## Town of Cottesloe

### Proposed Foreshore Precinct Toilet Facility

### CONSULTATION ANALYSIS REPORT

# Proposed Foreshore Precinct Toilet Facility

**Figure 1: Current Proposal Compared to Alternative Toilet Block Location**

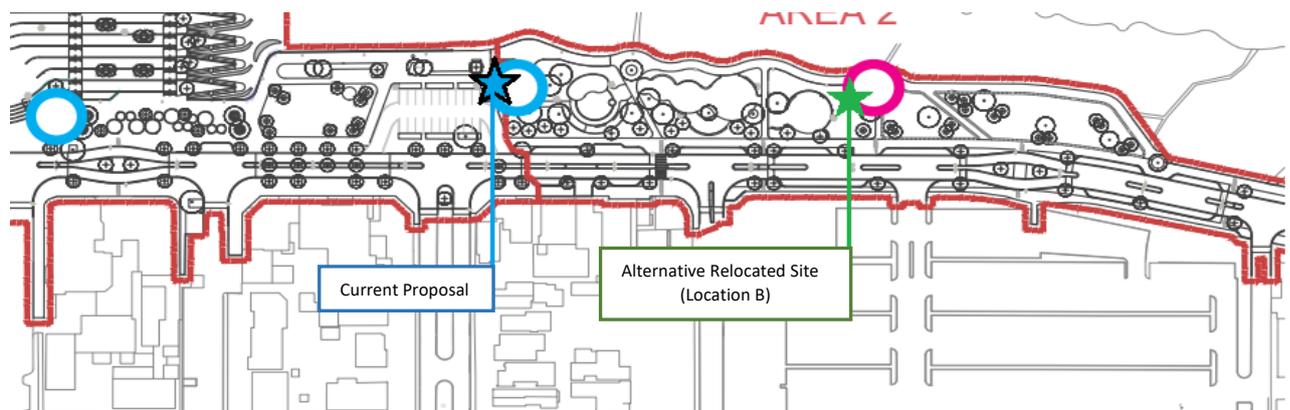
A review of the Cottesloe Foreshore area and the CFMP has been conducted to provide feedback on the proposed location and suggest possible alternative sites. We believe that repositioning the proposal 115m north of its current proposed location will be ameliorative, as it will not prejudice the Redevelopment Area and will still provide additional public toilets adjacent to the formalised play areas, beach access and the main car park on No. 2 Napier Street. This repositioning would put the proposal west of Marine Parade and Lot 39 and equidistant between Cottesloe and North Cottesloe in an area experiencing high levels of pedestrian traffic associated with the carpark and users of the playground facility. (See Figure 1). For ease of reference, we shall refer to the recommended repositioning of the proposal as “Location B”.

Relocating the proposal to Location B will situate it directly west of the large public car park that is bounded by Napier Street and Bryan Way. Additionally, this council-owned carpark is proposed to be further expanded under the CFMP. Under the plan, the lot will still maintain its complete frontage to the section of Marine Parade between Napier Street and Bryan Way.

## Facility Layout

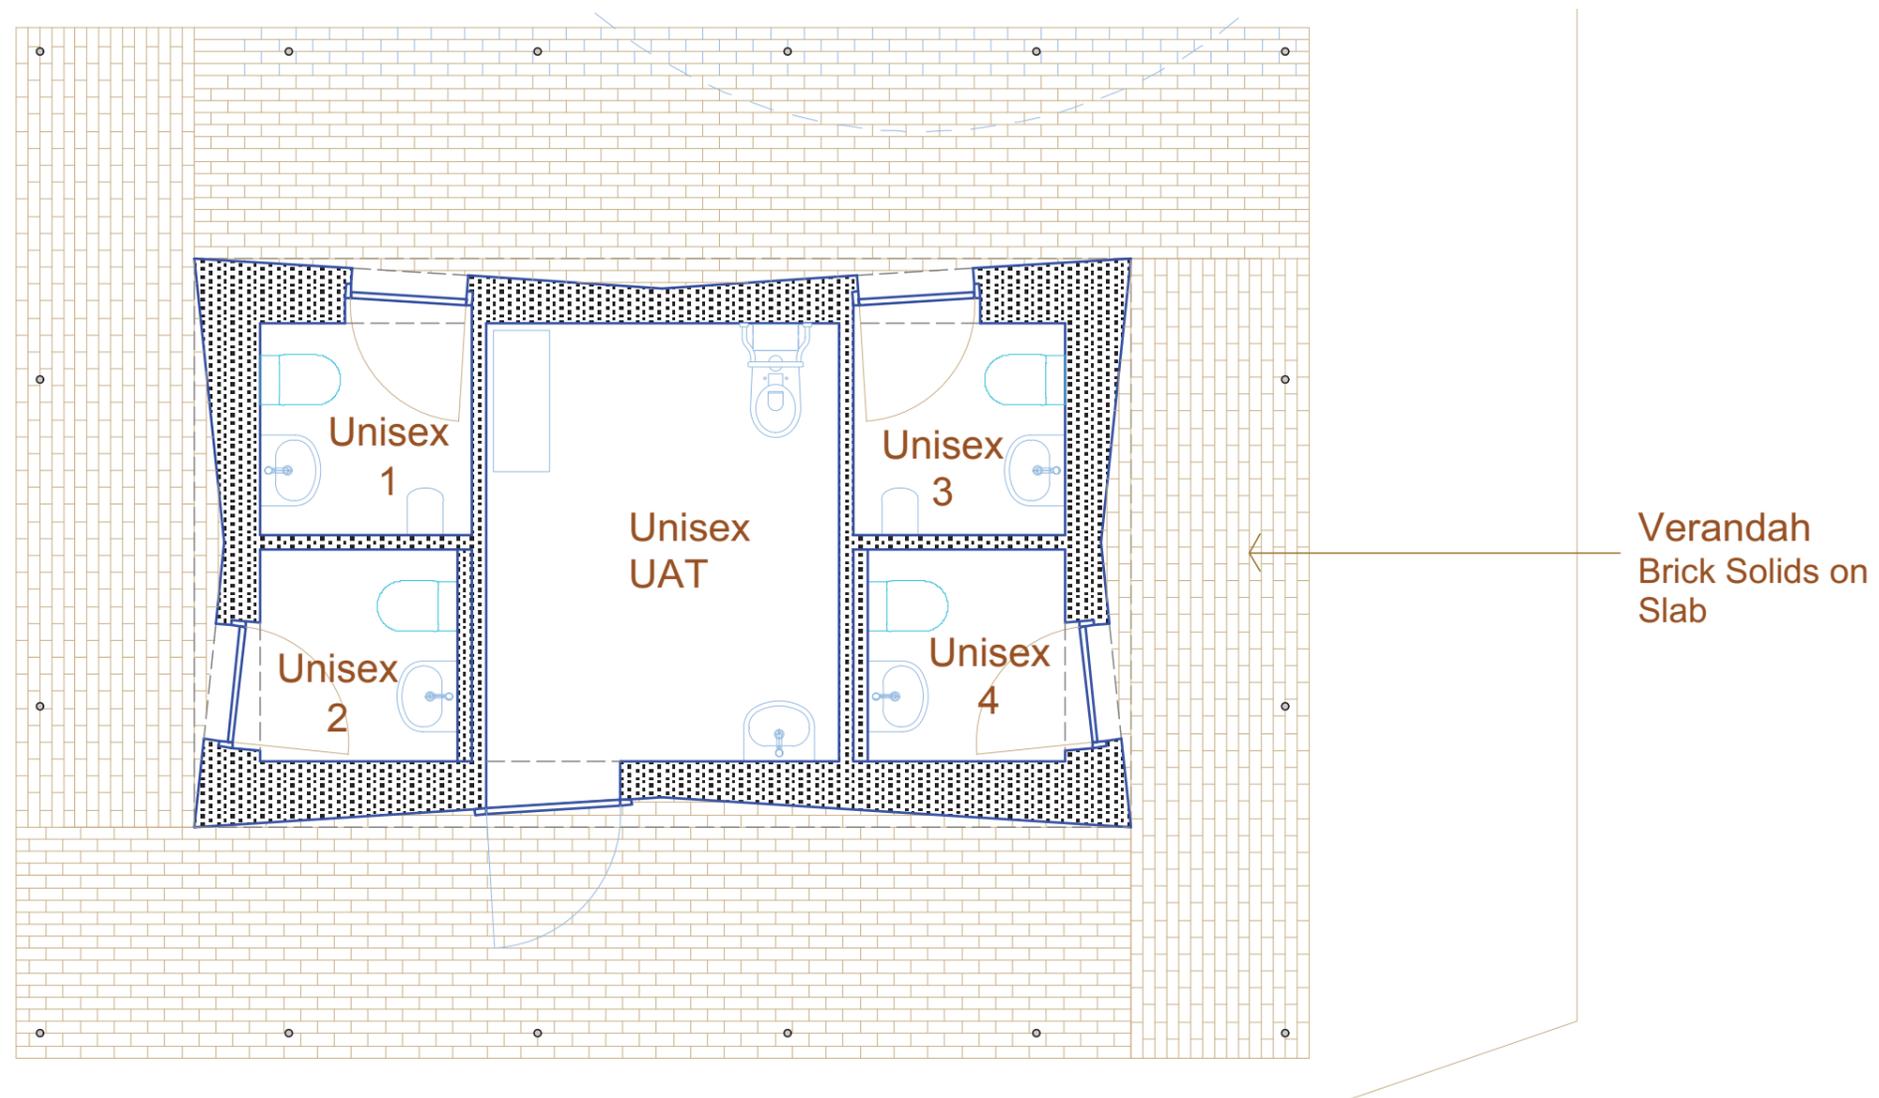
Further to our comment, may we suggest unconditionally that the large Unisex toilet at the centre of the toilet block be fitted out according to best-practice Changing Places specifications, which are available here: [Changing Places - Campaign for accessible public toilets](#)

Height comparison

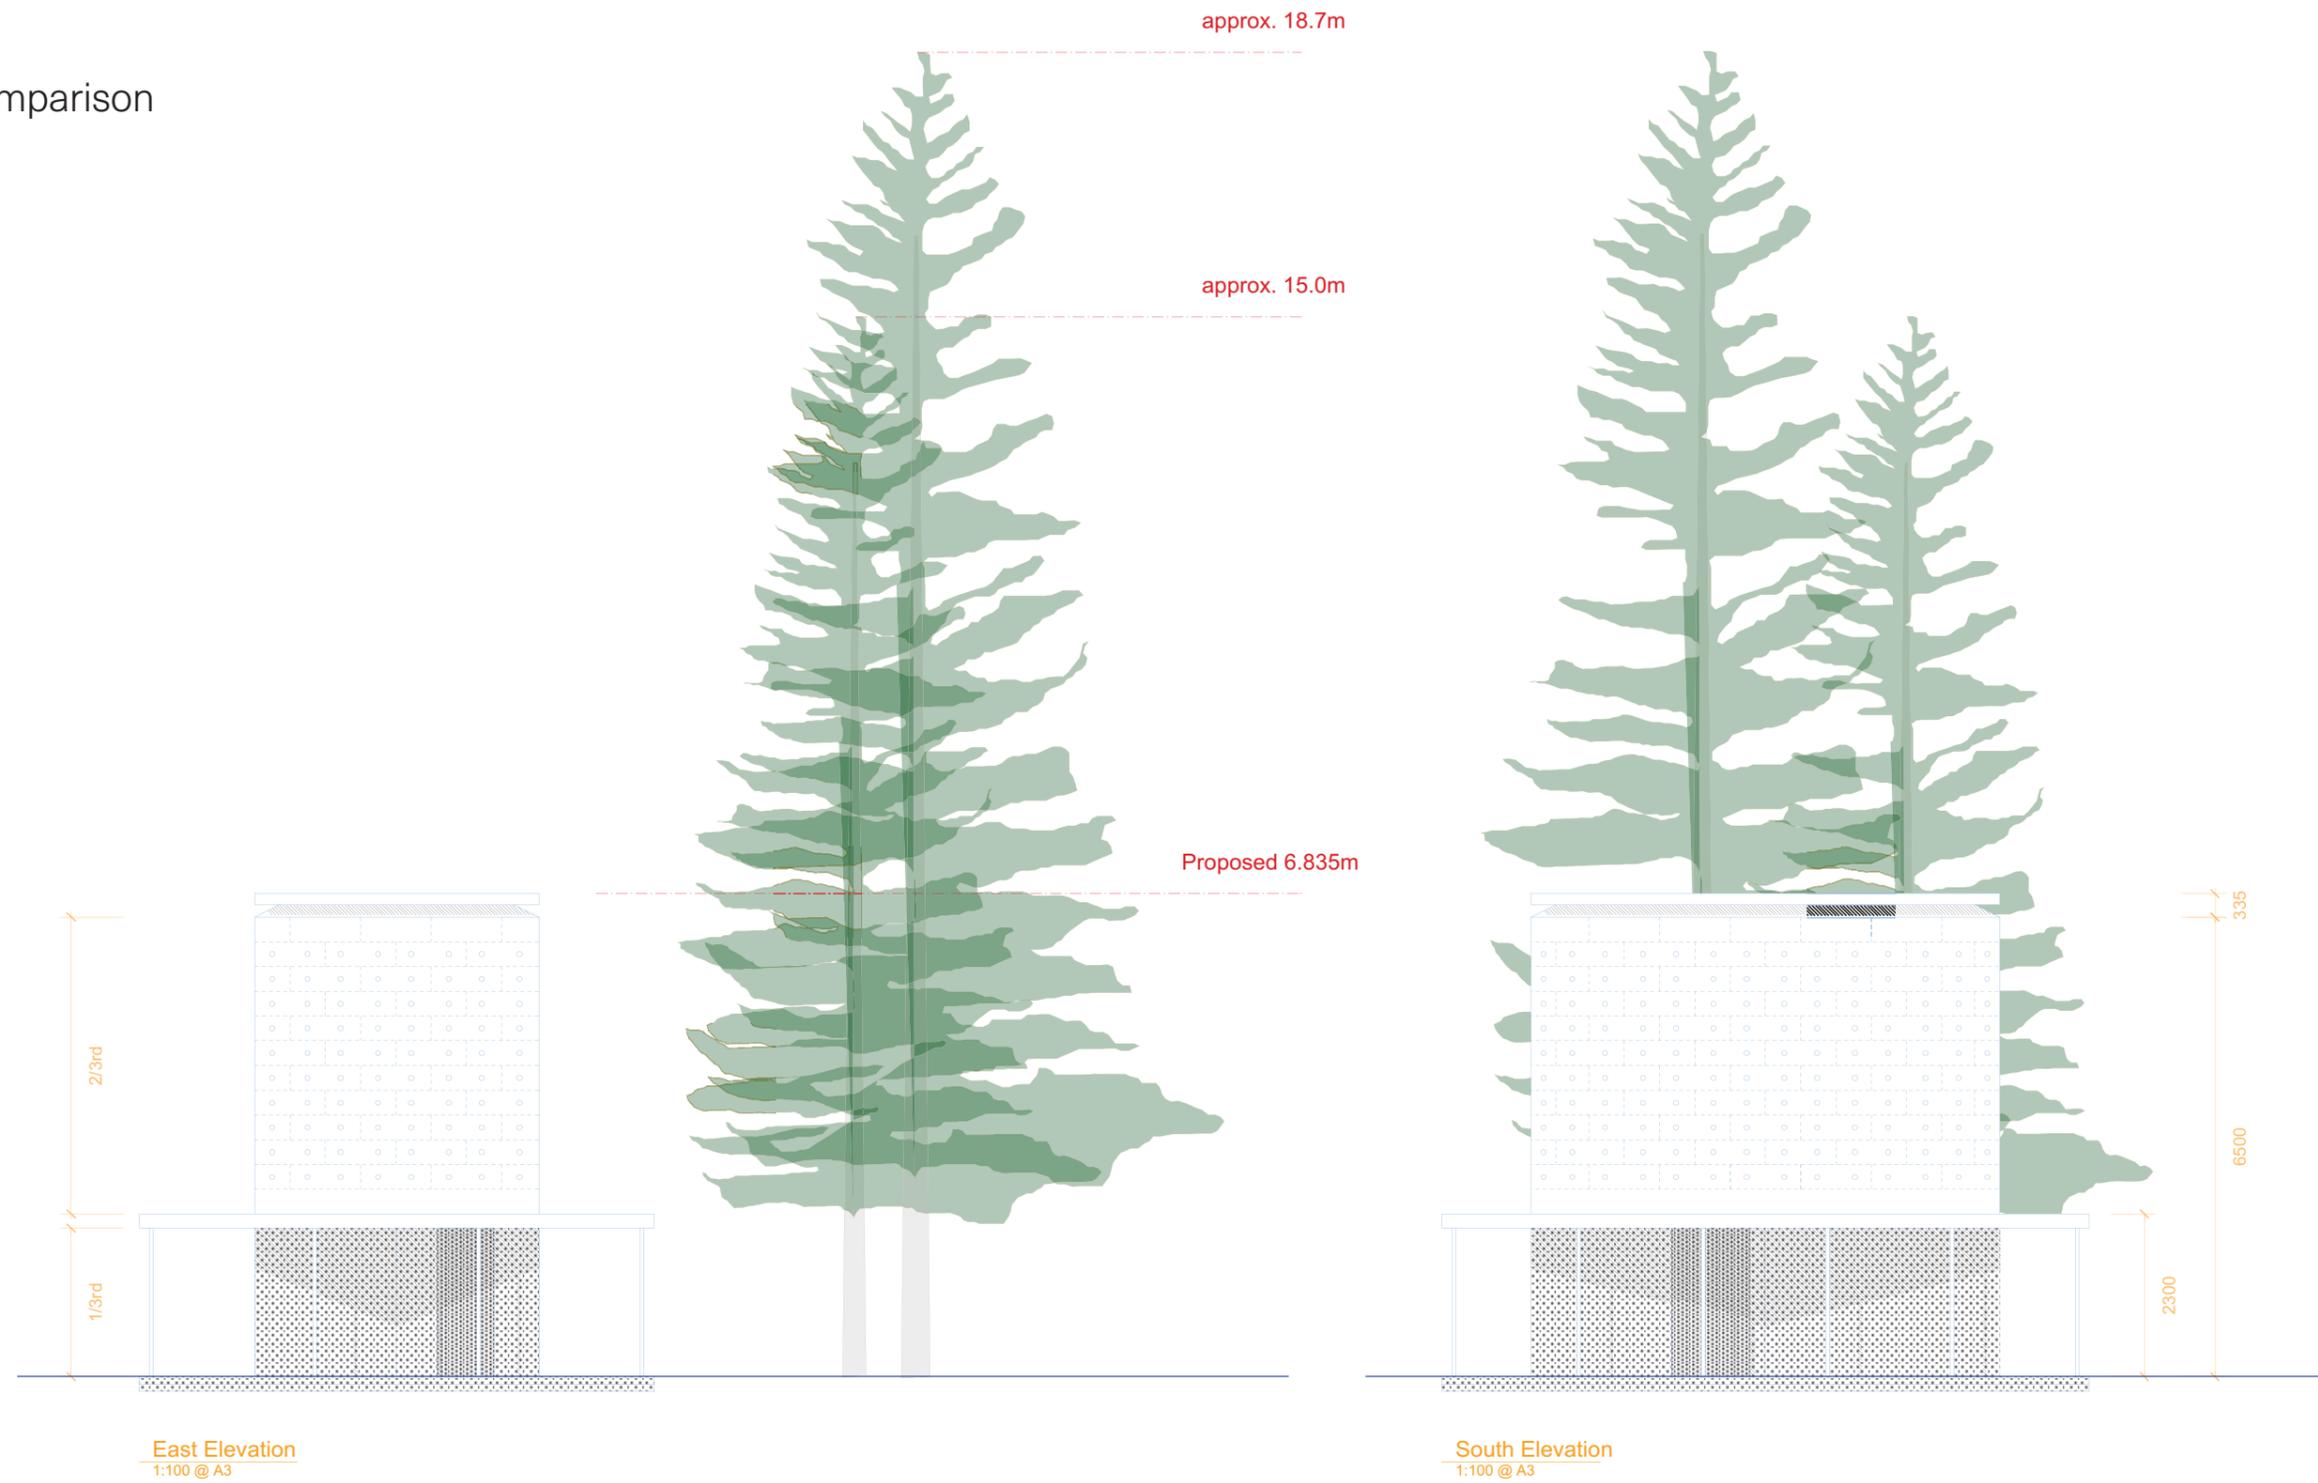
9	The building looks too tall and is out of proportion. Not sure why we need the 6m height.	5/17/2021 7:35 PM
10	There is absolutely a need for this toilet facility (and more at appropriate distance) in Cott. The height of the structure concerns me, could it be less obtrusive?	5/17/2021 5:30 PM
11	The toilet layout and location makes sense but the structure is just too tall. Only needs to be 4 metres high as it is just a toilet block	5/17/2021 3:31 PM
12	If built it may be an oddity rather than an icon. It is too high visually and may well have a higher vulnerability to the elements. Materials proposed are consistent with the area. Suggest just halve the height and deal with light and ventilation in usual way. if built, watch for kids using holes as climbing points.	5/17/2021 3:00 PM
13	Why does it need to be so high? It would look better with a reduced height top section. If a long term vision was possible, it may be better placed in the new carpark two development and not directly on the foreshore area. Please include baby changing facilities - there is nothing suitable in the area at the moment.	5/17/2021 3:00 PM

maintain a similar design & construction material without being 7m high. There is no need for 7m, 3m- 4m maximum would be entirely sufficient.

59	I like the natural materials being used and the 5 toilets. I don't like the 6.8m height of the toilet facility. It will highlight a toilet and detract from the ocean vista.	5/13/2021 9:45 AM
60	The facility should have minimal visual impact on the foreshore and should be as low profile as possible. Suggesting a 7 metre edifice high ludicrous!! and an eyesore	5/13/2021 9:38 AM
61	There has been no information on cost. Regardless, Town funds would be better served invested in other facilities and services.	5/13/2021 1:13 AM
